Westinghouse Electric Company LLC
Hematite Decommissioning Project
3300 State Road P
Festus, MO 63028
USA

Subject: Response to Request for Additional Information Concerning Hematite
Decommissioning Plan: Chapter 5, Dose Modeling (License No. SNM-00033,
Docket No. 070-00036)

**Response to Request for Additional Information
Hematite Decommissioning Plan:
Chapter 5, Dose Modeling**

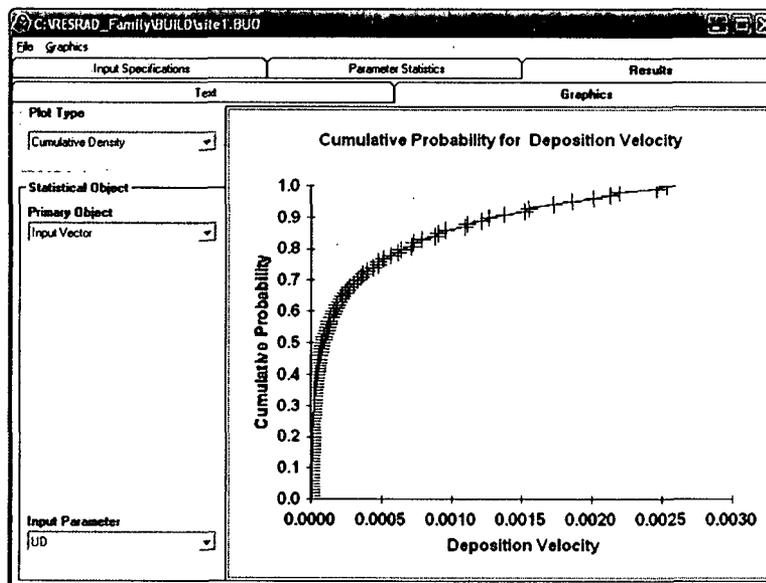
13. (HDP-C5-Q13) Comment: It is not clear how the median, 25th, and 75th percentile values used in the RESRAD-BUILD analyses were calculated from the distributions provided in NUREG-6697.

Basis: The values used in the RESRAD-BUILD analyses for parameters such as the deposition velocity, resuspension rate, building exchange rate, and the source lifetime were based on median, 25th percentile, and 75th percentile of distributions presented in NUREG-6697 as described in Section 5.4.3.1 of the DP. However, it is not clear how these values were calculated from these distributions.

Path Forward: Provide a description of the methodology used to calculate the median, 25th percentile, and 75th percentile values from the distributions in NUREG-6697.

The median and 25th and 75th percentiles of NUREG/CR-6697 distributions were calculated using the following process. A RESRAD-BUILD default case was used with all default values except that the source type was set to area. All default "Sample specifications" under "Uncertainty Analysis Input Summary" were used except that the number of repetitions was changed from 3 to 1. For each parameter of interest, the default parameter distribution was set (by hitting F8 on the parameter of interest). After RESRAD-BUILD performed the calculations, the "Uncertainty Graphics" module was run. From the "Graphics" tab, the "Cumulative Density" "Plot Type" was viewed with the "Primary Object" set to "Input Vector." For Deposition Velocity, "UD" was selected as the "Input Parameter." See the following figure.

On the plot, the cumulative probability curve was right-clicked with the mouse and the option “Edit Chart Data...” was selected. For Deposition Velocity, the median value was determined by first finding the value of “0.5” in column “C2.” Then, the corresponding “C1” value was selected as the median of the NUREG/CR-6697 distribution for Deposition Velocity. See the figure below which shows the source of the 8.07×10^{-5} m/sec provided in Section 5.4.3.2 of the DP.

**REPLACEMENT FIGURE 5-3
Ra-226 Impacted Area**

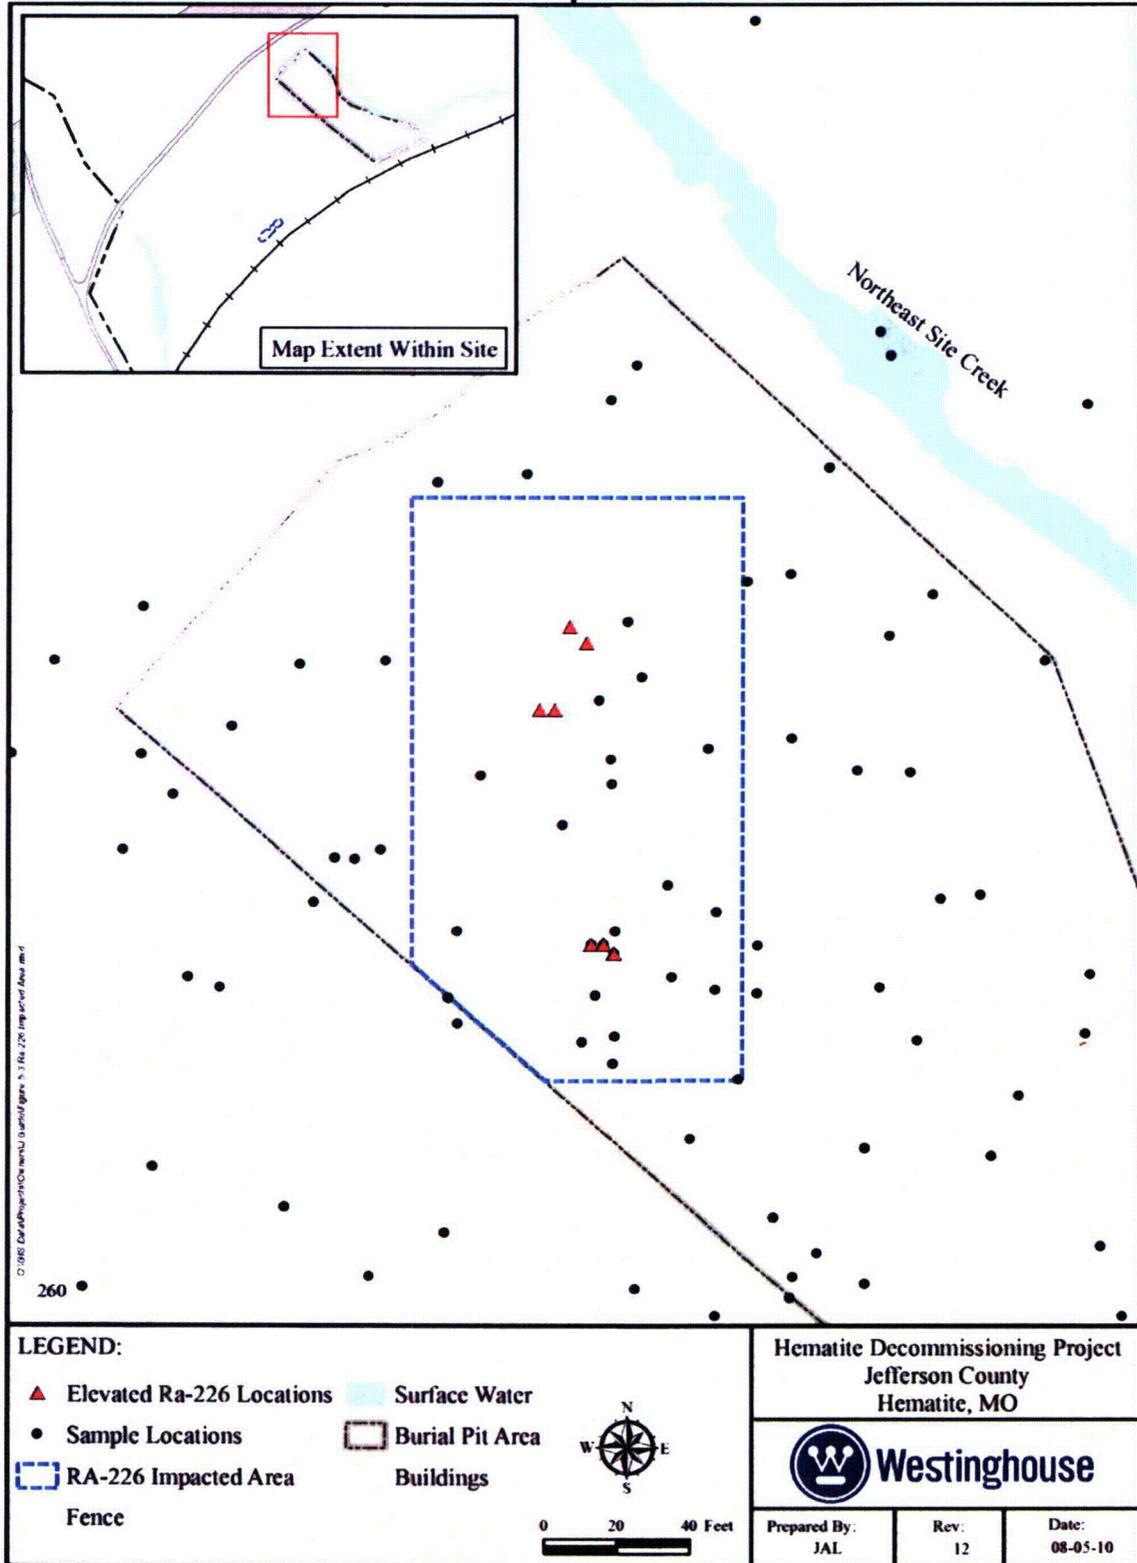
1. (HDP-C5-Q1) Comment: The Hematite Decommissioning Plan (HDP), Section 5.2, states that Ra-226 and Th-232 are only found in certain locations of the site, but the location and extent of contamination is not thoroughly illustrated. Also, the Th-232 model assumes the entire surface area of the site is contaminated even though it is stated to be found in limited locations. Also, it is unclear if these radionuclides will be measured for across the entire site area during the Final Status Survey (FSS) to ensure they meet the derived concentration guideline levels (DCGLs).

Basis: The area of the contaminated zone is a necessary RESRAD input parameter for determining the DCGLs. Section 5.2 of the DP discusses how Th-232 and Ra-226 are modeled separately from the other Radionuclides of Concern (ROCs). In HDP Figure 5-3, Ra-226 Impacted Areas, the legend uses a triangle to designate "Elevated Ra-226 Locations." However, the diagram does not have any triangles identifying the Ra-226 locations within the "Ra-226 Impacted Area." The DP states that Th-232 is only found in certain locations within the area of buried waste and that Ra-226 is only present at two locations within the buried waste. The Hematite Radiological Characterization Report (HRCR) describes Th-232 in isolated areas in the Burial Pits Soil, and Soil Southeast of the Process Buildings and Surrounding Areas. However, in Table 5-6 of the DP describing the RESRAD Input Parameters, the size of the Th-232 model contaminated zone is the entire site area of 153,375 m² while the Ra-226 model assumes a limited area of 1,292 m². It is unclear why the area is not reduced in the Th-232 model if the contaminant is only found in certain areas. If a larger area was intended to be used, then it is unclear why Th-232 was modeled separately from the other ROCs.

Path Forward: Please provide an updated Figure 5-3 identifying the elevated Ra-226 locations. Also, provide further basis for the contaminated zone areas used in the Th-232 model. Also, clarify if Ra-226 and Th-232 will be measured for across the whole site area during the FSS and explain how the absence of Th-232 and Ra-226 in other areas of the site will be verified if those radionuclides will not be measured for in those areas in the FSS.

Figure 5-3 has been updated to identify the elevated Ra-226 locations and is included as Attachment 2. The confidence interval of 1.6 pCi/g provided in Hematite Decommissioning Plan (DP) Section 4.3.5 was used to define elevated Ra-226 concentrations.

Because Ra-226 was identified only in a limited portion of the site, Ra-226 radioactivity concentration will only be included for demonstrating compliance in the Ra-226 Impacted Area (RIA, HDP Figure 5-3). DP Section 14.4.4.2.6 states: "Finally, gamma spectroscopy results for each sample will be reviewed for other gamma-emitting radionuclides present." This process allows Ra-226 contamination outside of the Ra-226 Impacted Area to be identified, however unlikely based on the Historical Site Assessment (HSA) and RCR findings. Should Ra-226 contamination exceeding the confidence interval of 1.6 pCi/g (provided in DP Section 4.3.5) be identified outside the RIA, the magnitude and spatial distribution of the contamination will be investigated to ensure compliance to the release criterion.

**Summary of Modeled Geometries for External Dose from Buried and Excavated Piping
Figure 1 through 4**

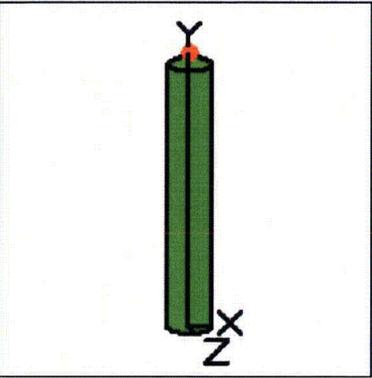
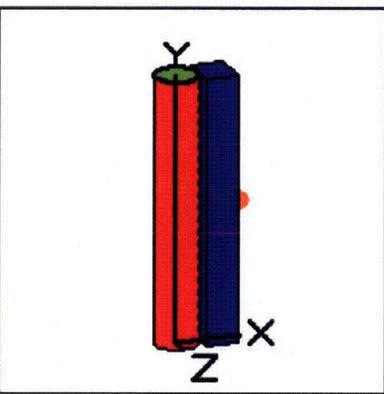
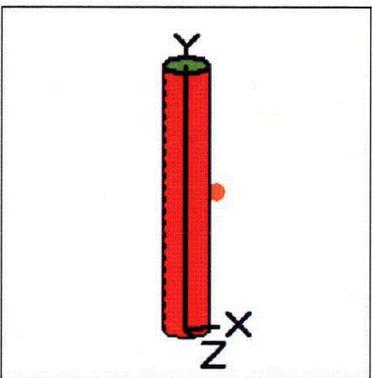
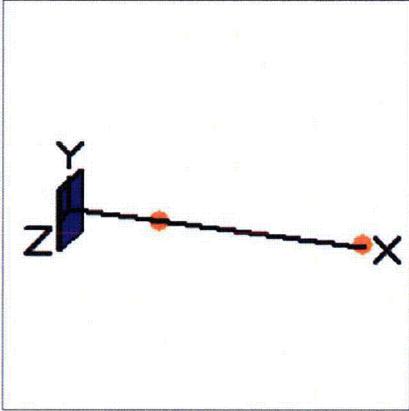
19. (HDP-C5-Q19) Comment: The conceptual model used for calculating the DCGL values for the pipes described in Section 5.5 does not seem consistent with the expected configuration of the residual contamination following decommissioning activities.

Basis: There are several aspects of the conceptual model assumed in calculating the DCGL values for pipes that need additional clarification. In the calculation of these DCGL values, it is assumed that the pipe is filled with soil that has an activity of radionuclides equal to the DCGL values calculated for the root depth soil layer (i.e., 15 cm to 1.5 m). These volumetric DCGL values were then converted to an areal value on the interior surface of the pipe, which is effectively equivalent to assuming a dilution of the material on the surface of the pipe over the whole volume of the pipe. This resulted in the proposed areal DCGL values to be larger for large pipes than for small pipes because in the large pipes the material was averaged over a larger volume. The pipes that remain on site at the time of license termination may remain in service and may not be filled with soil, so it is not clear that this conceptual model applies. In addition, the dose to an individual may be different from a thin skin of contamination on the surface of the pipe than from a volumetric source containing the same amount of activity. Furthermore, the contribution of the pipes to the dose for the resident and building occupant scenarios is not considered and the potential dose from the pipes being excavated and reused is not considered. Information on the depth of the pipes below the ground surface was also not provided. The depth of the pipes can have a large impact on the dose because of the shielding from the soil or pavement above the pipe.

Path Forward: Provide additional justification for the assumed conceptual model used in the development of the DCGL values for pipes, including the basis for assuming that the residual contamination in the pipes is averaged over the volume of the pipe. Alternatively, a new calculation of DCGL values for the pipes can be performed and provided along with justification for the conceptual model assumed in the new calculation. The potential dose from the pipes to the building occupant and resident receptors should be considered, and the potential dose from a pipe that is dug up and reused should also be considered. Information on the depth of the pipes below the ground surface should also be provided.

The conceptual model for buried piping DCGL calculations assumes that the pipes remain *insitu*, and was primarily intended to address smaller diameter pipes with potential for contamination from operations. The dose in an occupied building due to external exposure from buried piping underneath the building foundations and containing residual radioactivity equivalent to the proposed buried piping DCGL is very low as shown in Attachment 4, Figures 1 and 2. The dose to an excavation worker from excavated piping containing residual radioactivity equivalent to the proposed buried piping DCGL is also expected to be low due to limited contact time with the excavated pipe as shown Attachment 4, Figures 3 and 4.
